**Chemung County Stormwater
Construction Inspection
Erosion and Sediment Control**

Project Name Dollar General	Date 8-23-2019
Location Pennsylvania Ave Southport (T), NY	Permit # NYR11F148
Weather Conditions overcast	Entry Time: 11:27 am
On-Site Representative Present: none	Exit Time: 11:42 am

PROJECT: Dollar General
Town of Southport
Municipal Inspection
August 23, 2019

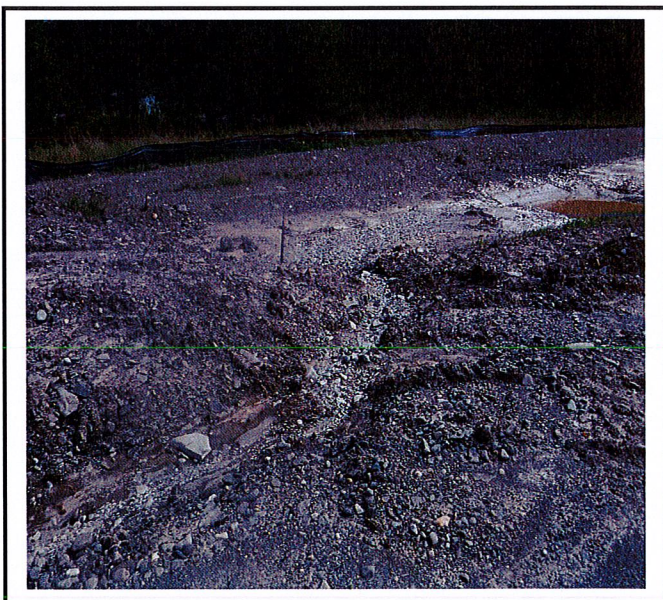
Concrete washout at capacity. Trucks washing next to it.
